**RAI Volume 3, Chapter 2.2.1.3.2, Fourth Set, Number 2:**

Demonstrate that the dimensions of the tessellated domain in the UDEC-Voronoi model do not affect significantly the calculations of rockfall volume from seismic events.

Figure 1. Contours of Displacement (m) for Previously Collapsed Drift after Subsequent Shaking by Ground Motions with  $1 \times 10^{-4}$  Probability of Annual Recurrence

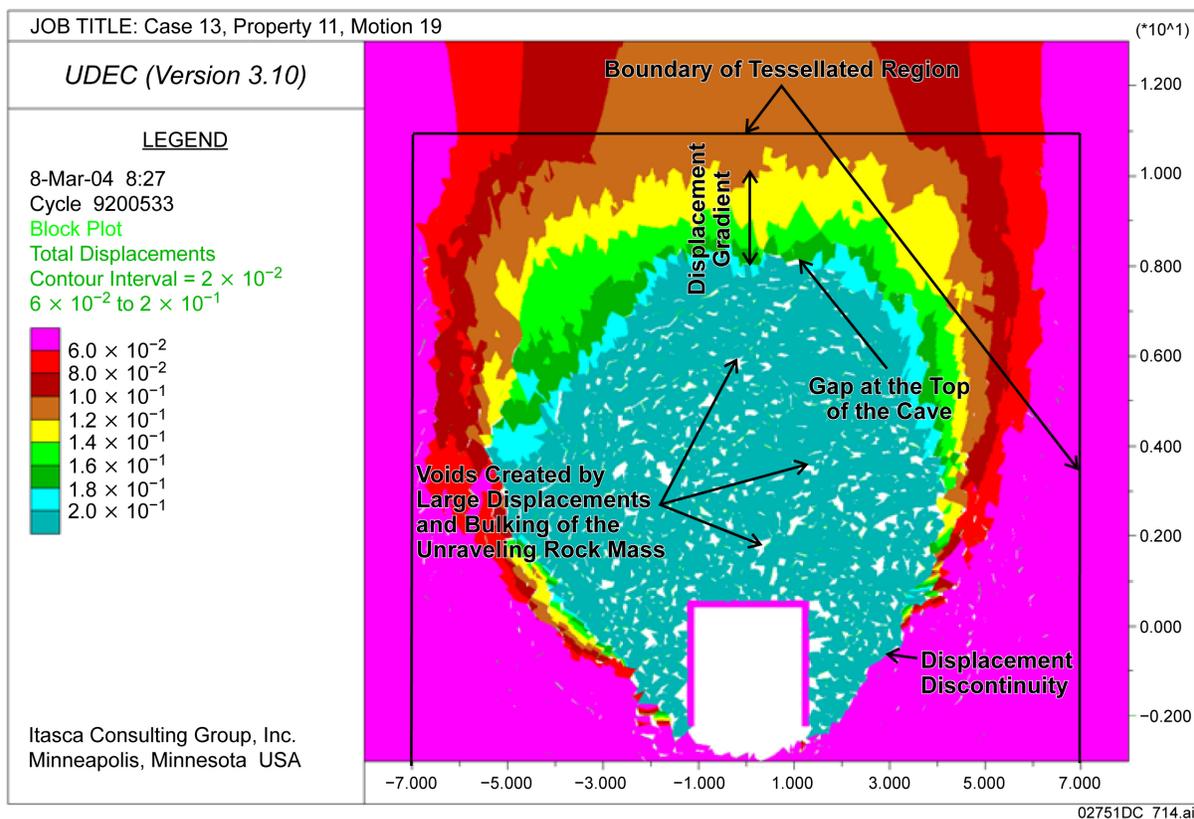
**Basis:** The upper boundary of the tessellated domain in UDEC-Voronoi model is set 10.25 m above the initial drift roof (BSC, 2004, Figure 6-116). However, contours of block displacement magnitude intersect the upper boundary of the tessellated domain, indicating that some additional displacement occurs outside this domain (e.g., BSC, 2004, Figure 6-176). Also, plots of the final position of the Voronoi blocks after an analysis (e.g., BSC, 2004; Figures P-17, P-18, and P-24) indicate blocks at the top of the model could be predicted to separate from the overlying elastic domain, which would suggest the caved zone might have extended higher if the model upper boundary had been higher. DOE does not provide a technical basis for the selecting the dimensions of the tessellated domain, and does not provide sensitivity analyses in BSC (2004, section 6.4.2.1) to demonstrate that uncertainty in the dimensions of the tessellated domain do not affect significantly the calculations of rockfall volume during seismic events.

The configuration of the emplacement drift and displacement contours after drift collapse and shaking by a seismic event<sup>1</sup> with a  $10^{-4}$  probability of annual exceedance is shown in Figure 1. The figure also shows the outline of the region tessellated in the Voronoi blocks. The contours of certain displacement values (e.g., greater than 0.1 m, as shown as the brown region in Figure 1) cross the upper boundary of the tessellated domain, indicating that additional displacement occurs outside this domain. The reasons for deformation outside the tessellated region are the following:

However, deformation of the elastic overburden (as indicated in Figure 1) does not mean that the caved region expanded to the boundary of the tessellated region, or that the boundary affected the size of the caved region. If a boundary effect were present, gaps would occur along the boundary of the tessellated region. These gaps would be manifested in the displacement contours as displacement discontinuities or regions of large displacement gradients. As shown in Figure 1, the displacement discontinuities and regions of large displacement gradients are

completely contained within the tessellated region. Moreover, the displacement field crossing the boundary of the tessellated region is continuous, indicating that near the boundary the tessellated region and the outside elastic domain are mechanically equivalent and deform continuously.

Voids resulting from large block displacements exist in the contour plots and appear as white spaces between the blocks. The voids are consequences of unraveling of rock mass and large displacements that include block rotations. Figure 1 indicates that most of the voids are contained within the region where displacements are 0.2 m or greater and that all of the voids are completely contained within the boundary of the tessellated region. No major voids have been identified in the vicinity of the boundary of the tessellated region.
